HGI Part No.	21/08/2020  HENRY JTP APPROVED DOCUMENT
1110-16

Description 产品名称	Flare Washer 1" 锥垫片 1"		
Drawing No. 图纸编号	M040201477	REV 版次	B
Material Master No. 物料编号	040201477	Drawing Size 图幅	A4
Material 材质	T2	Sheet Number 页码	1/1
Attribute 属性	N/A	Third Angle Projection 第三视角

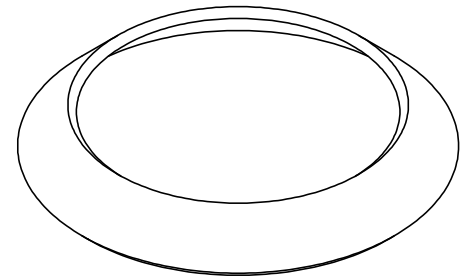
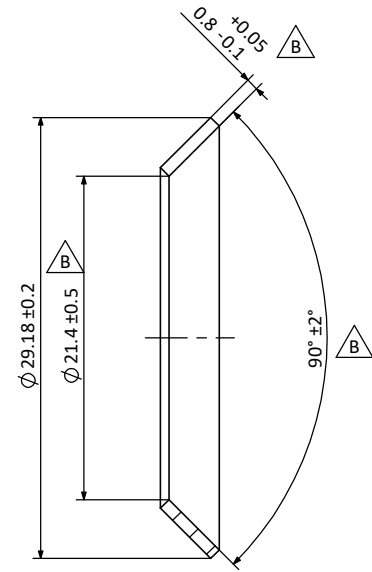
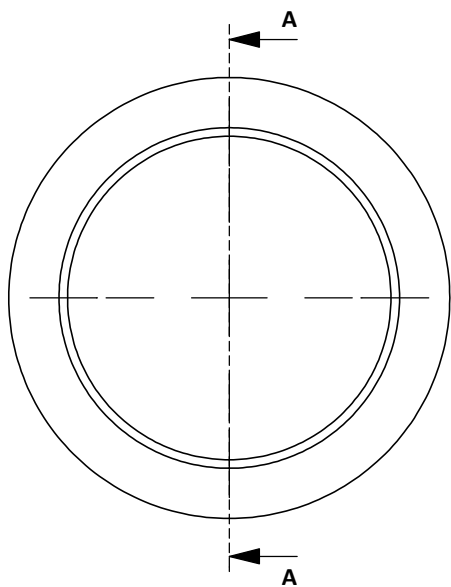
REV. 版本	ECN 工程变更通知	Description 变更描述	Name 变更人	Date 变更日期
B	ECN-HT20060	Change material from TP2 to T2, Add the tolerance $\phi 21.4 \pm 0.5$ , $0.8 (+0.05/-0.1)$ replace $0.9$ , $90^\circ \pm 2^\circ$ replace $45^\circ \pm 2^\circ$	Qiu Leixin	2020/08/18
